Overview: Production error; immobilizer wire (orange/black) in pin position #4 instead of pin position #5. Although an effort to correct the issue was made, some quantity of harnesses did get shipped before the issue was spotted. We are advising to inspect the harness BLADE connector before attempting to install the harness and program the module.

Overview: The FTI-STP1 harness may require modification for use in **automatic transmission (AT)** applications, some of the product was able to be modified before release, but a small quantity was released before being able to be modified internally.

FTI-STP1: Vehicle Coverage and Preparation Notes

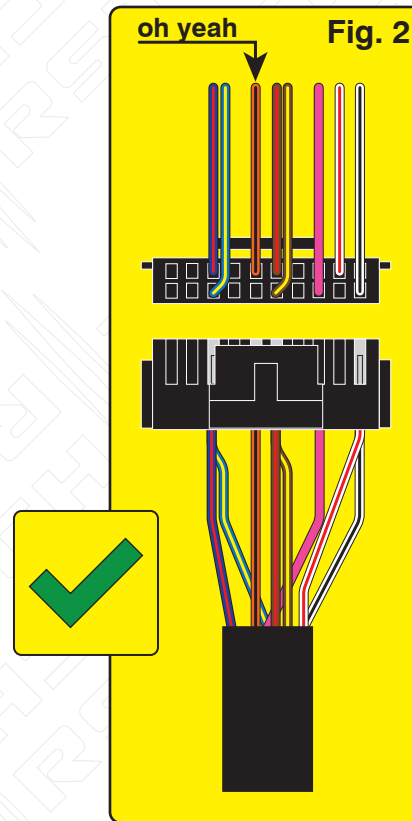
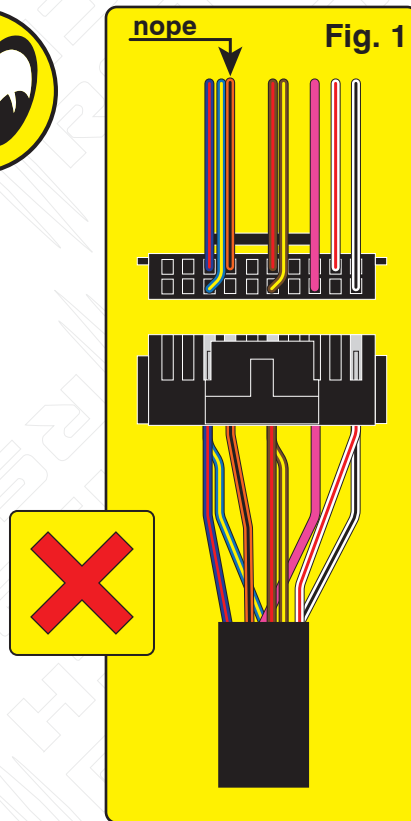
Issue: Module fails to program to vehicle, will not allow the vehicle to be remote started.

Correction: Step 1.) Locate the orange/black wire and confirm whether it is positioned as illustrated in Fig. 1 or Fig. 2. If the wire is as illustrated in Fig.1, proceed with Step 2 through 5 and complete the repair procedure outlined, if the wire is as illustrated in Fig. 2, correction is not necessary, proceed with harness installation and module programming.

Step 2.) Using a pick, lightly depress the catch that secures the terminal in the housing then remove the wire and terminal from the housing.

Step 3.) Using a fine tip razor or utility knife, insert the blade beneath the terminal catch and raise it slightly, so that it can be reused to secure the terminal when reinserted into the BLADE connector housing.

Step 4.) Refer to Fig, 2 for correct position of the orange/black wire (next to brown/red) then reinsert the terminal, pressing lightly until the catch 'snaps' into place, securing the terminal in the connector housing.

Step 5.) The repair is complete, proceed with installation and programming.

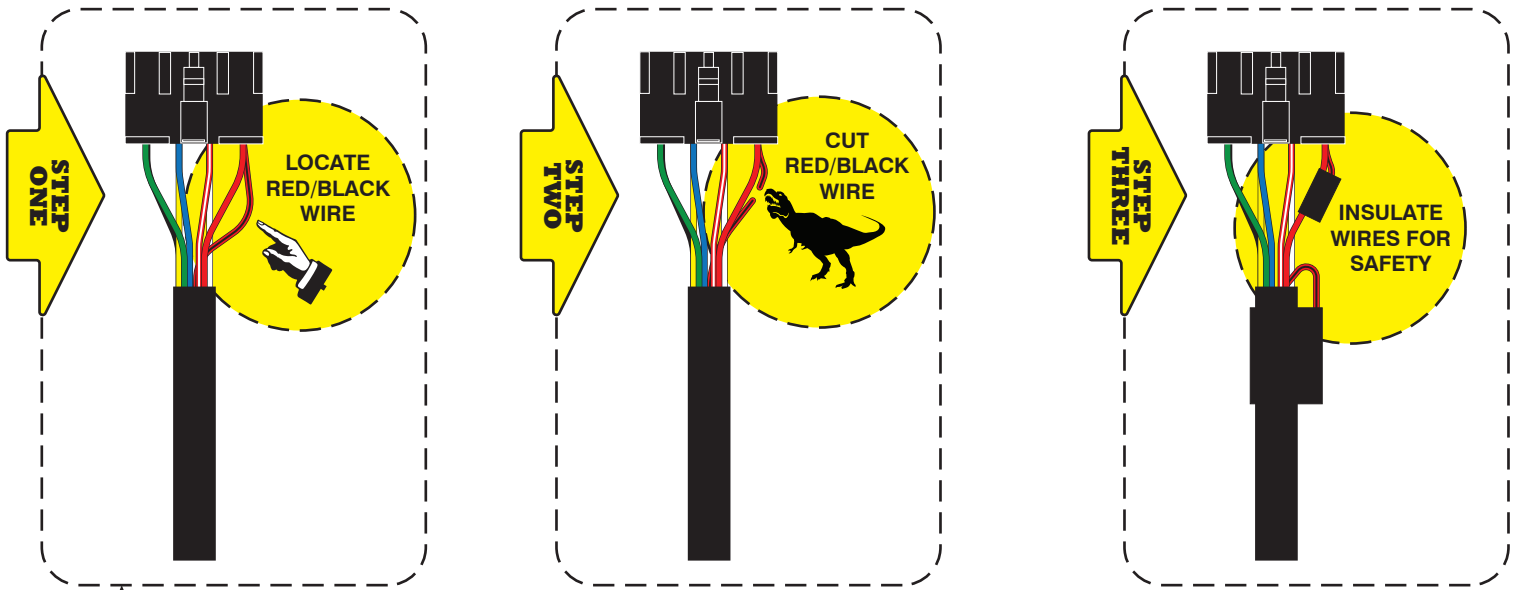
Issue: The FTI-STP1 T-harness has been designed to be compatible with AT (automatic transmission) & MT (manual transmission) applications, but due to a production oversight, the selection mechanism was defaulted to MT mode.

Using a harness configured for an MT application, in an AT equipped vehicle, could result in vehicle module damage, it is advised that the harness be returned to AT mode before installation in vehicles equipped with an automatic transmission.

Correction: Locate the **red/black** (+ Clutch) wire provided in the CN1 connector of the main harness assembly. Cut the **red/black** wire, either flush to the CN1 connector, or leaving enough wire exposed so that you can insulate and secure the ends of the wire that remain after cutting. Insulate each of the remaining ends of the **red/black** wire and secure to prevent any possibility of a short circuit.

If the red/black wire already been disconnected, no further modification is required for AT equipped vehicles.
